SUBSURFACE WASTEWATER DISPOSAL SYSTEM APPLICATION

AUGUSTA PERMIT # 1,298 TOWN COPY

Town Or Plantation	Augusta
Street Subdivision Lot #	Wilson St. (Easement extension)

SUBSURFACE WASTEWATER DISPOSAL PLAN

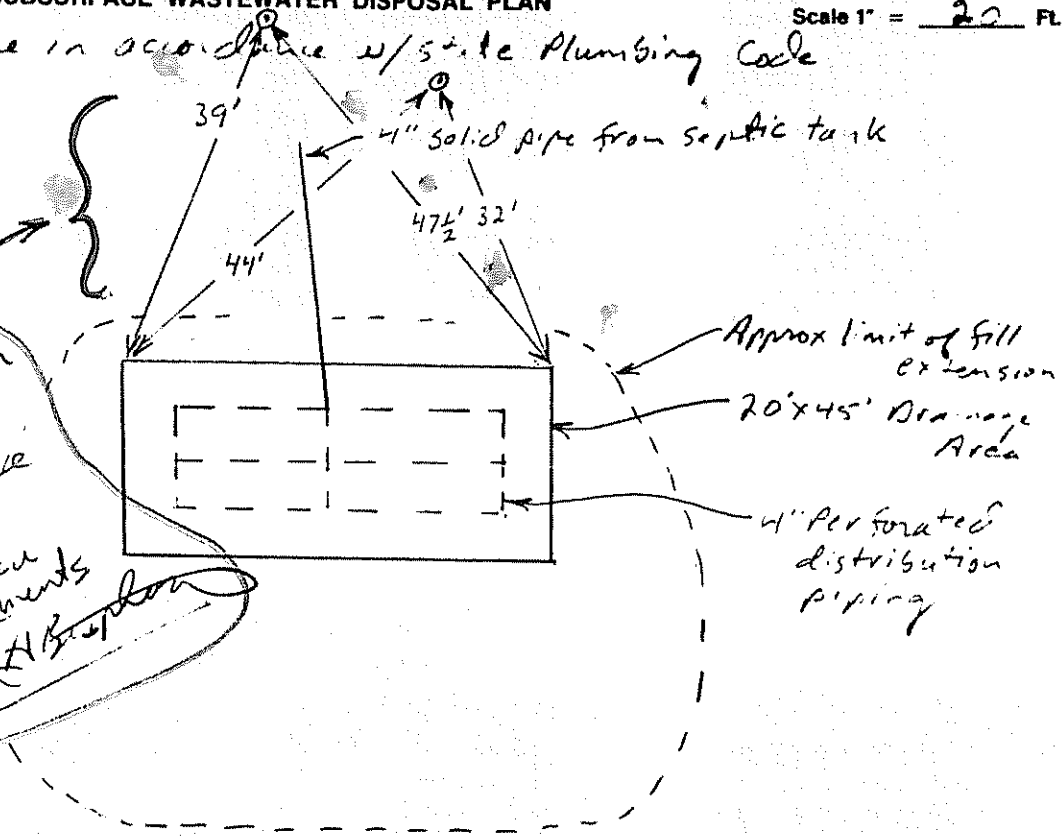
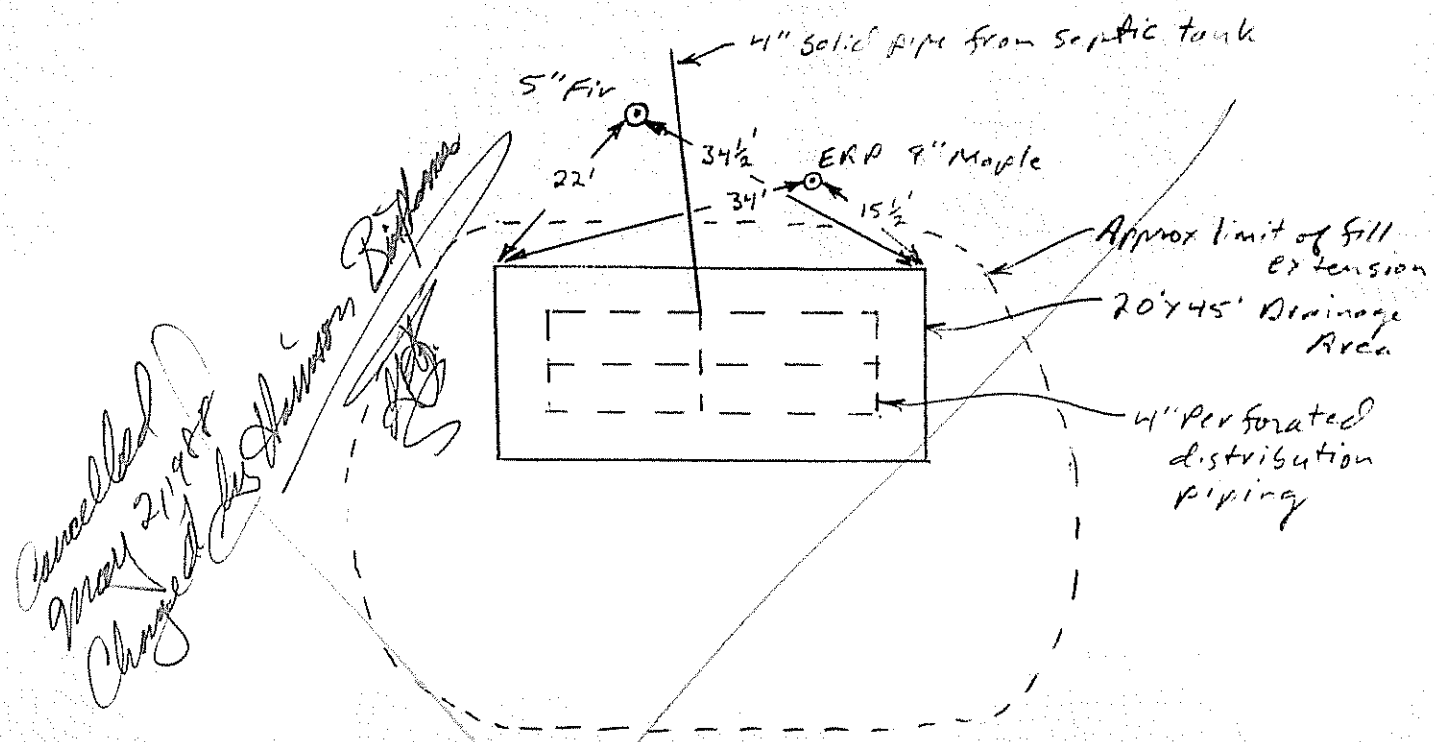
4/27/88 Revision
Drainage Area has been moved 20' Down slope in order to provide space for house w/in proper D.O.W. and Drainage Area setback requirements
Hanson
